REQUEST FOR INFORMATION NOT ADDRESSED IN THIS CCO REMAIN IN FORCE				
MARK	DATE	DESCRIPTIONS	BY	CH'D CCO#
3	02/17/12	CABLE TRAY COVER AT W2	RSB RG	234
2	03/01/11	BASE INTEGRATION	RSB WB	150
1	11/20/09	ELECTRICAL GROUNDING	RR AW RG FW	75
0	02/25/08	CABLE TRAY CHANGES	TW RG SE	4251

CONTRACT CHANGE ORDER NO. **234**
 SHEET **2** OF **7**

FOR REVISION ONLY
DETAILS UNDERGROUND PIER W2W PLANS AND SECTIONS
 SCALE AS NOTED

E-20B

E-21B

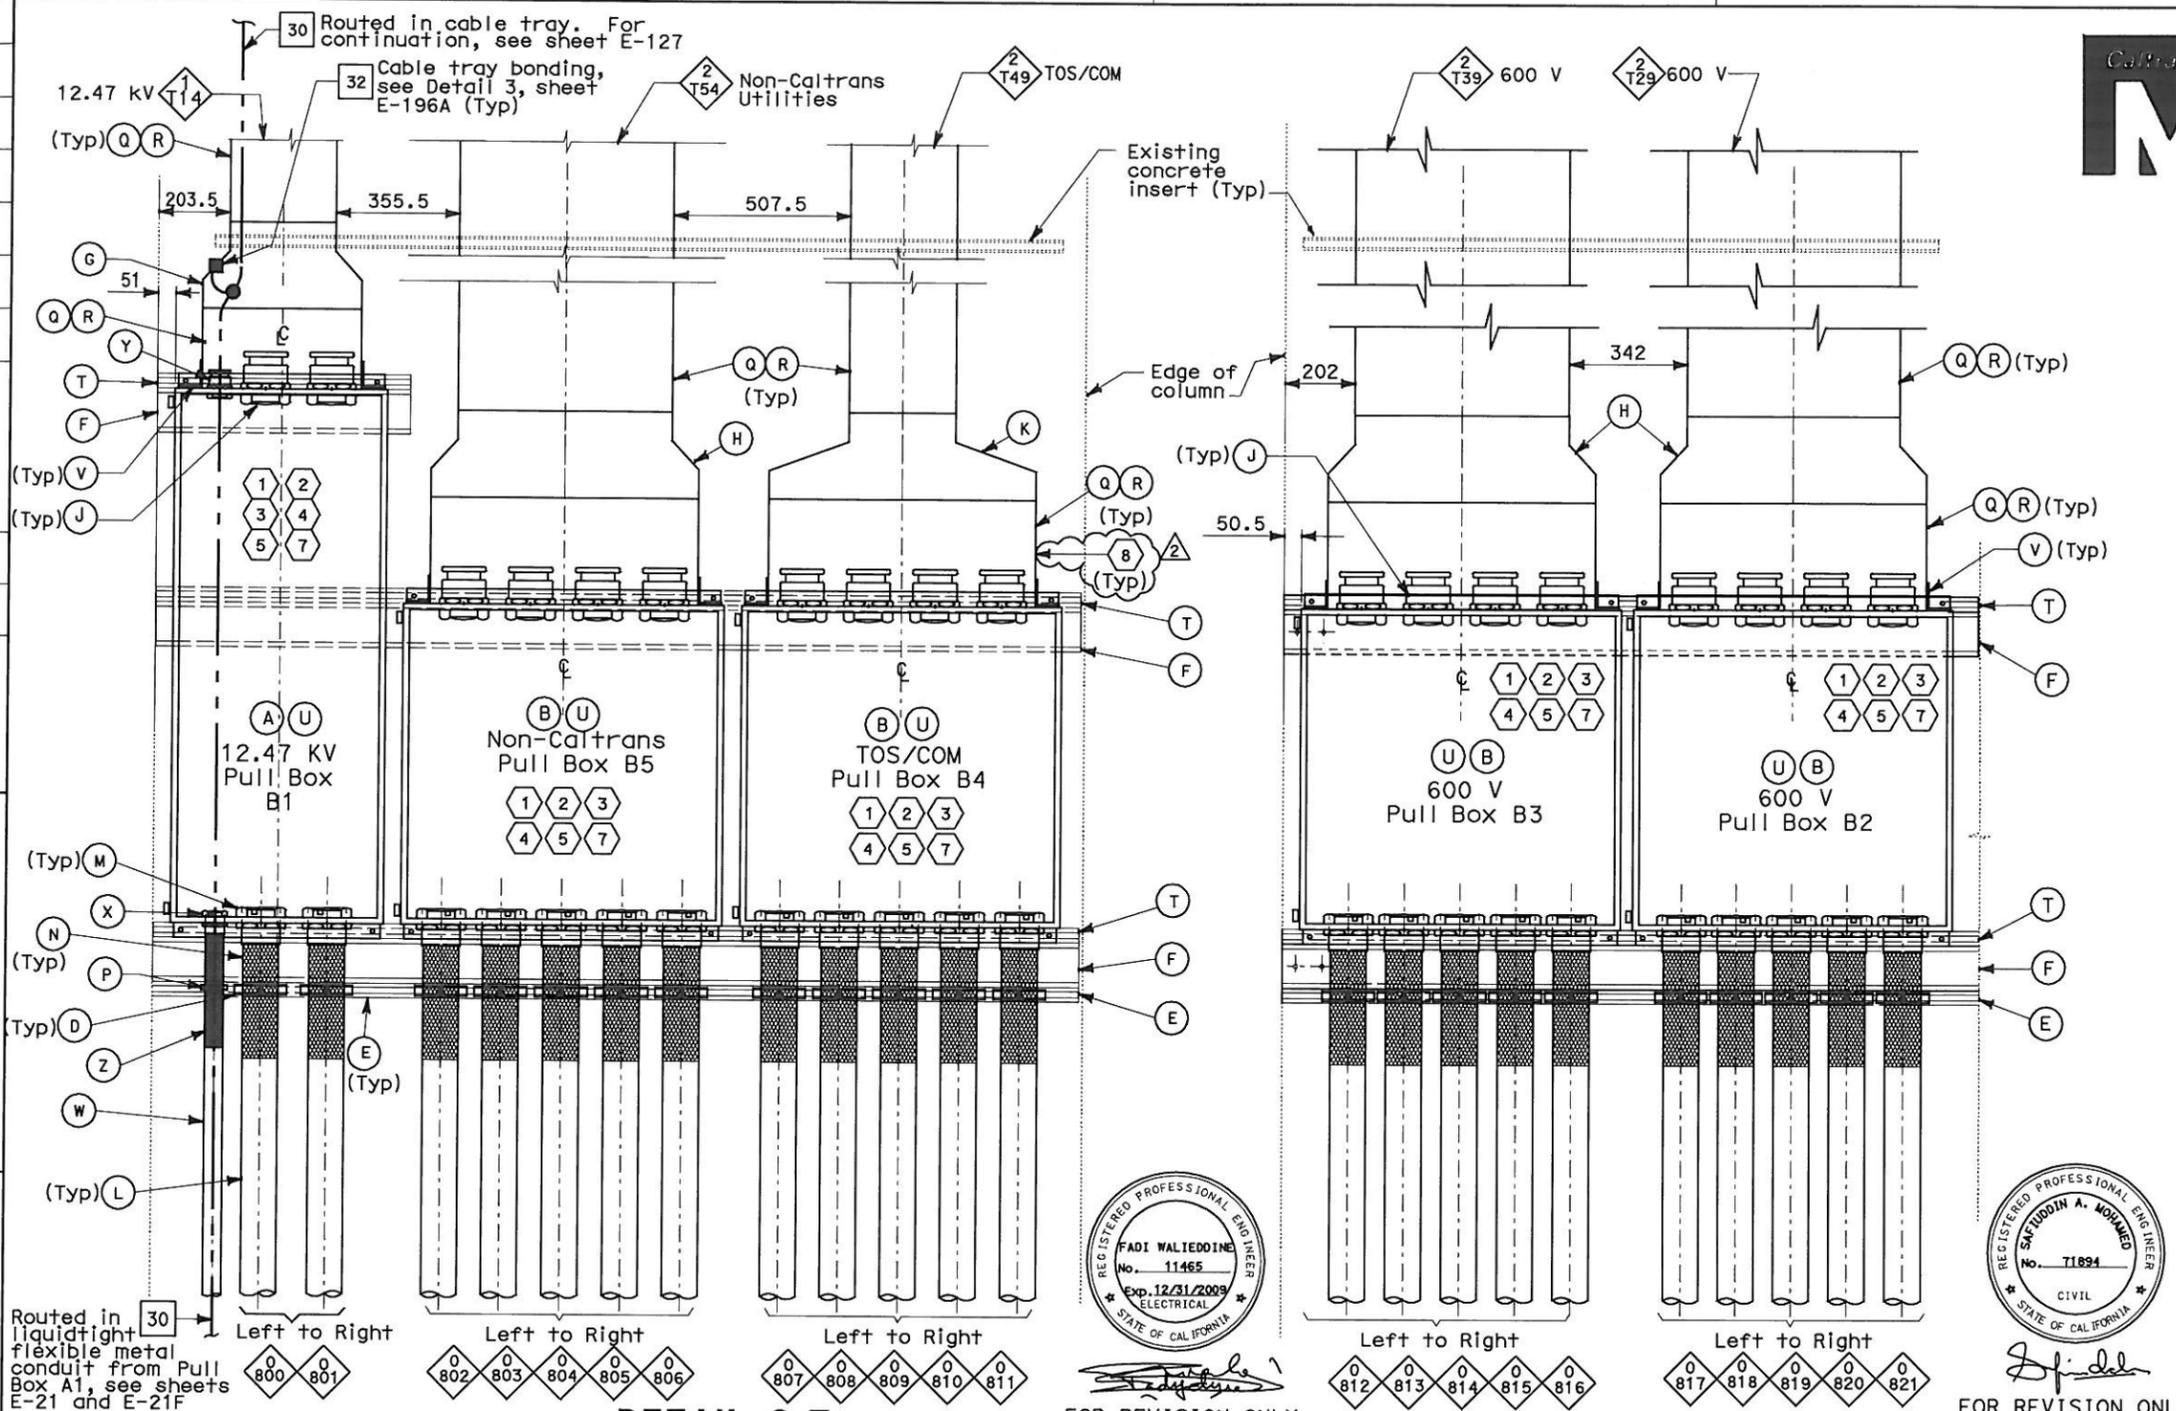
REQUEST FOR INFORMATION NOT ADDRESSED IN THIS CCO REMAIN IN FORCE				
MARK	DATE	DESCRIPTIONS	BY	CH'D CCO#
△	02/17/12	CABLE TRAY COVER AT W2	RSB	RG 234
△	11/20/09	ELECTRICAL GROUNDING	RR AWG	RG FW 75
△	02/25/08	CABLE TRAY CHANGES	TW	RG SE 42S1

⑧ For vertical cable tray not flush with the pier column wall, Contractor shall provide solid flanged cover on top and bottom of cable tray with approved heavy duty cover clamps.

**DETAILS
SAS SUPERSTRUCTURE GIRDER WESTBOUND
TYPICAL TRAY AND CONDUIT INSTALLATION AT PIER W2W**
SCALE AS NOTED

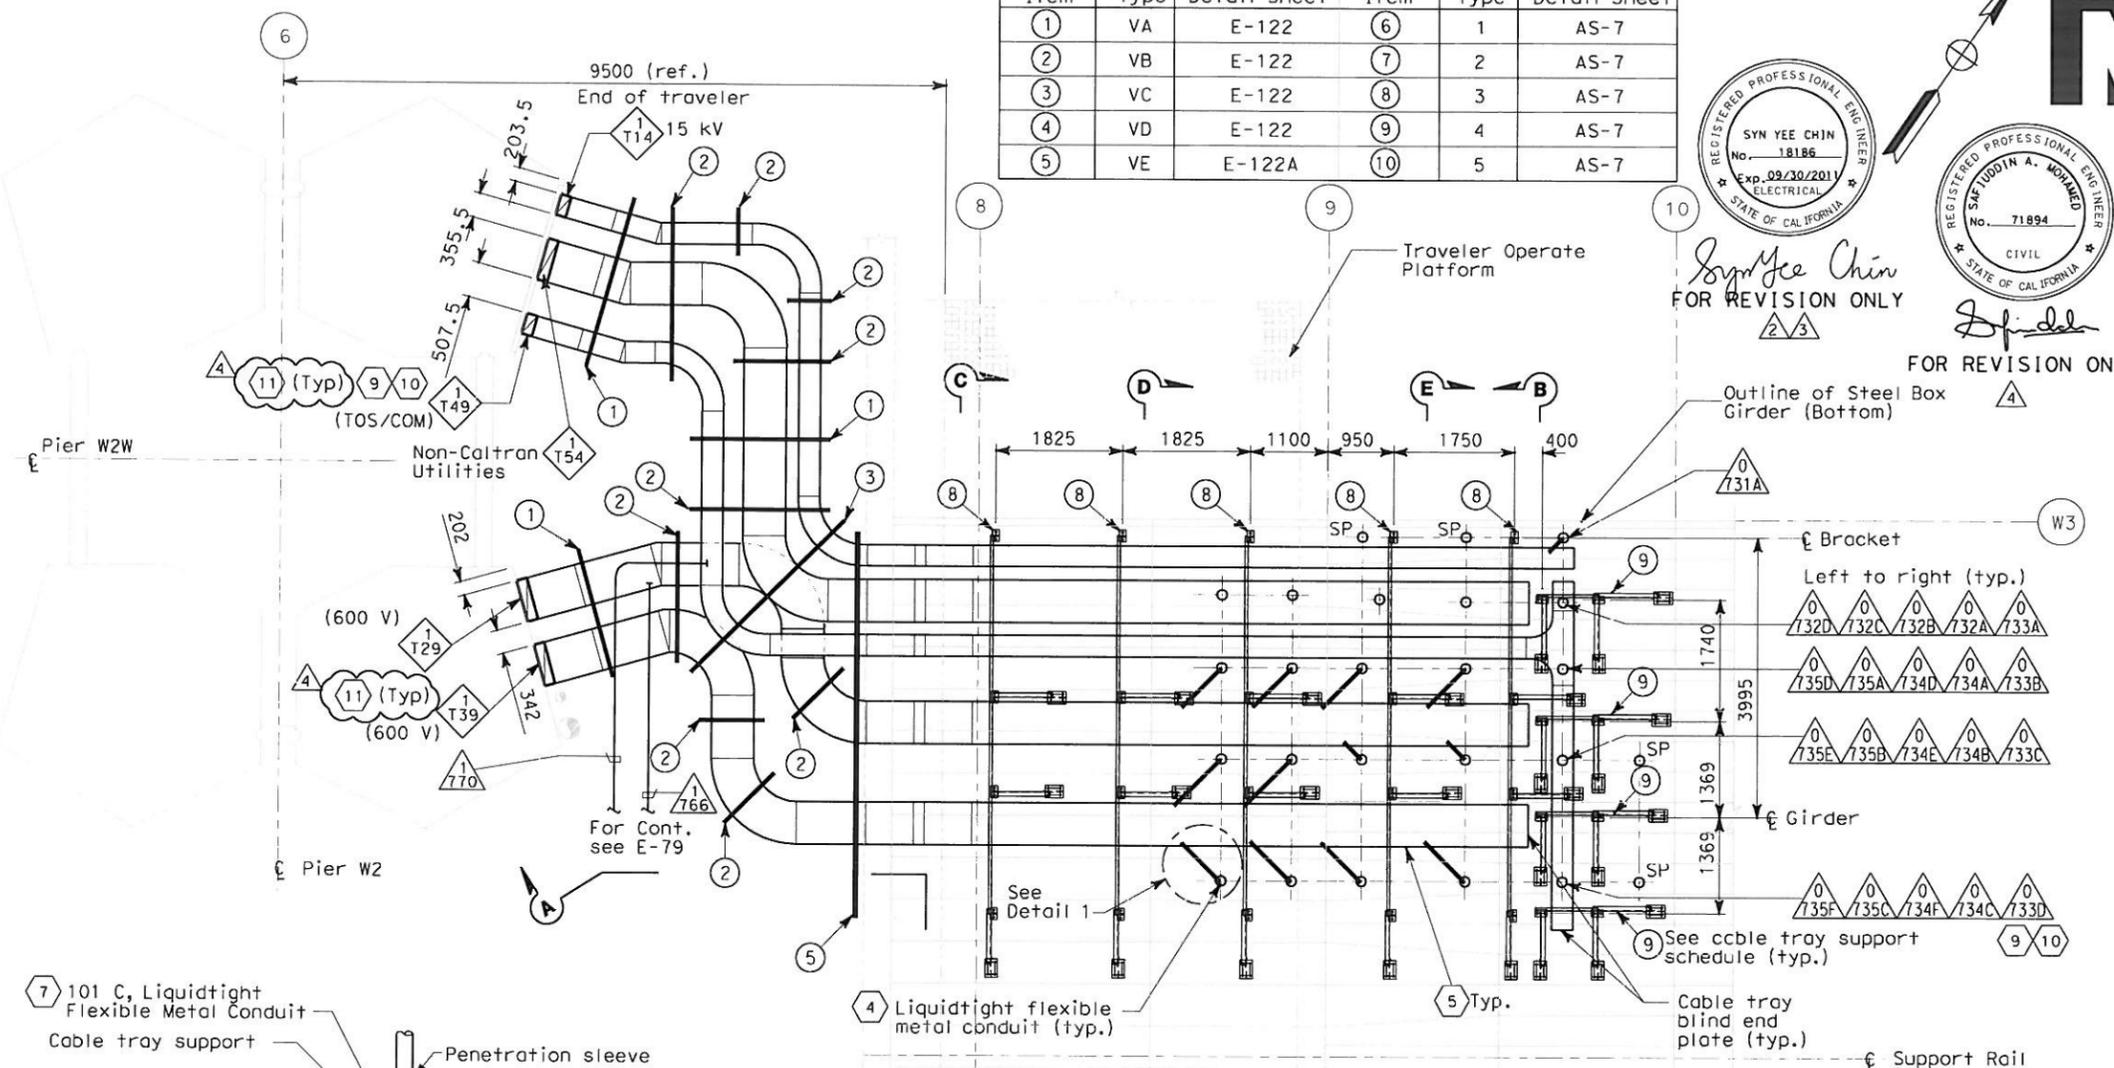
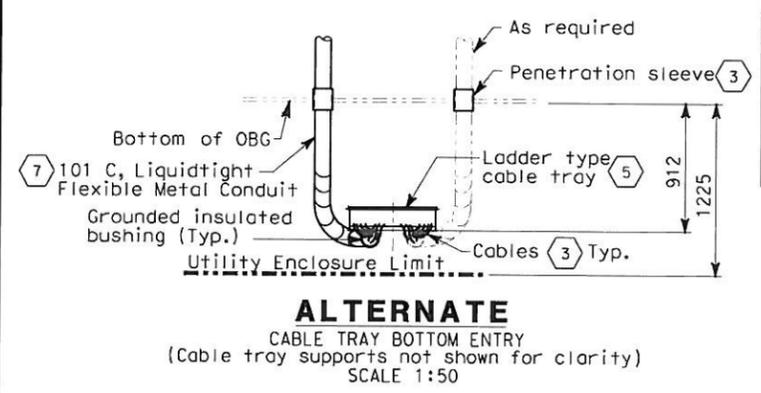
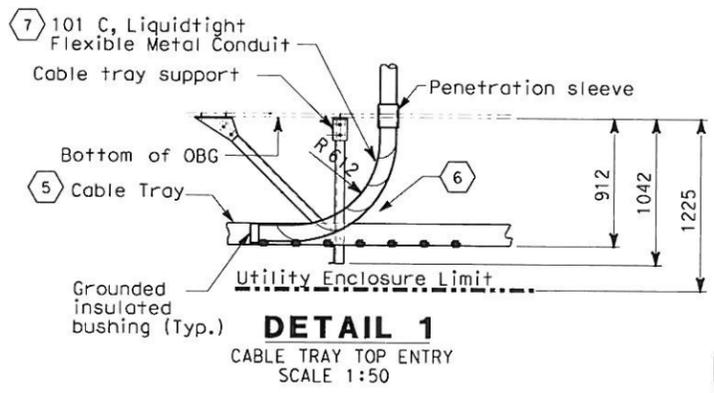
REQUEST FOR INFORMATION NOT ADDRESSED IN THIS CCO REMAIN IN FORCE				
MARK	DATE	DESCRIPTIONS	BY	CH'D CCO#
4	02/17/12	CABLE TRAY COVER AT W2	RSB	RG 234
3	03/01/11	BASE INTEGRATION	RSB	WB 150
2	03/26/10	DEHUMIDIFIER SCADA INTERFACE	RR	RG FW 130
1	02/25/08	CABLE TRAY CHANGES	RG	SE 42S1

11 All cable tray under the girder shall have peaked flanged cover on top and solid flanged cover at the bottom. Vertical cable tray on the column shall have solid flanged cover on top and no cover at the bottom except when cable tray is not flush with the pier column. Contractor shall provide solid flanged cover on top and bottom of cable tray. Approved heavy duty cover clamps shall be used as required.

E-212

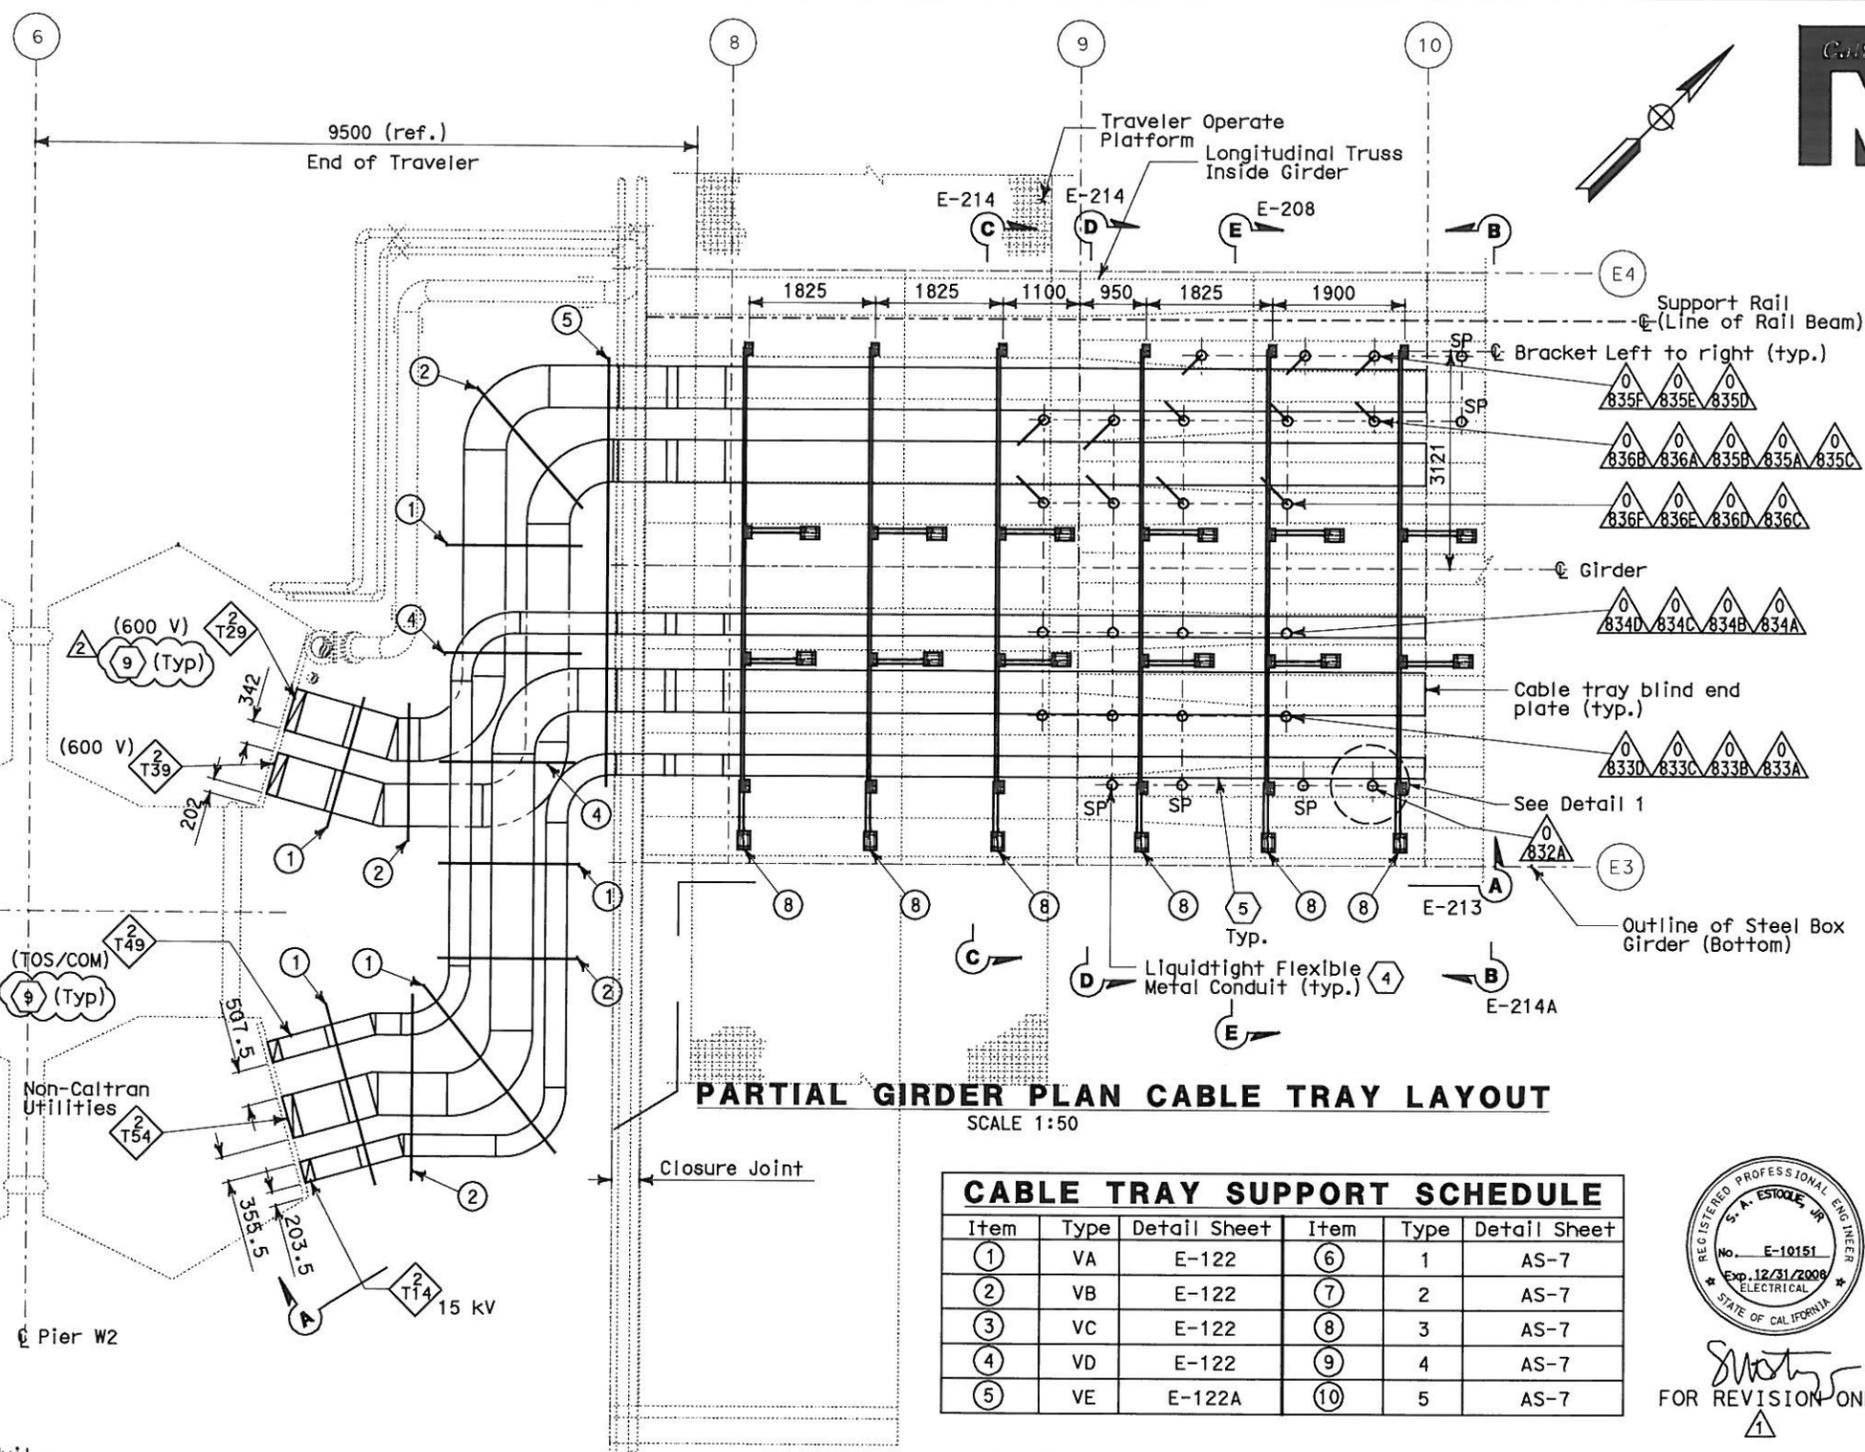
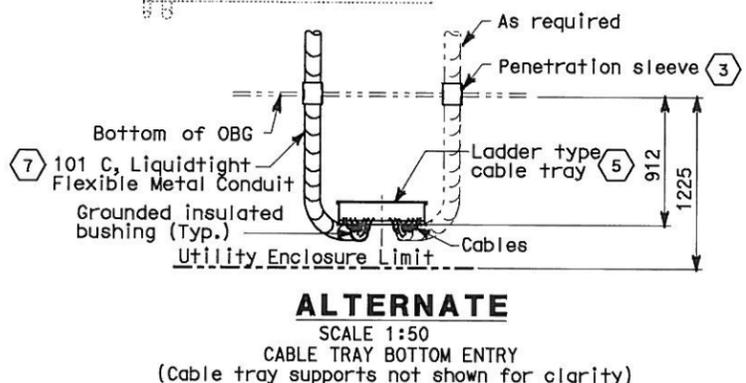
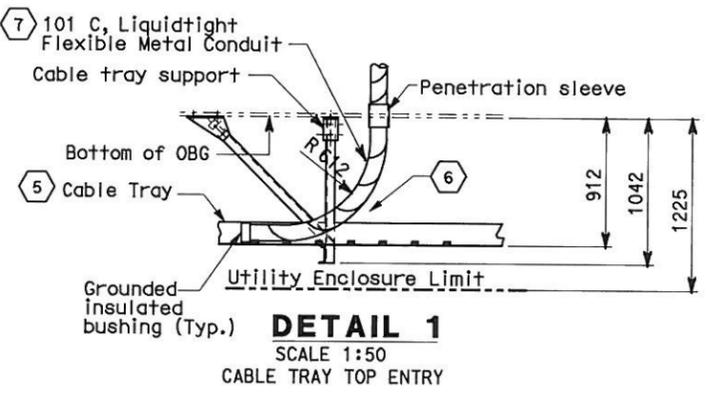
MARK	DATE	DESCRIPTIONS	BY	CH'D	CCO#
2	02/17/12	CABLE TRAY COVER AT W2	RSB	RG	234
1	02/25/08	CABLE TRAY CHANGES	RG	SE	4251

- All cable tray under the girder shall have peaked flanged cover on top and solid flanged cover at the bottom. Vertical cable tray on the column shall have solid flanged cover on top and no cover at the bottom, except when cable tray is not flush with the pier column, Contractor shall provide solid flanged cover on top and bottom of cable tray. Approved heavy duty cover clamps shall be used as required.
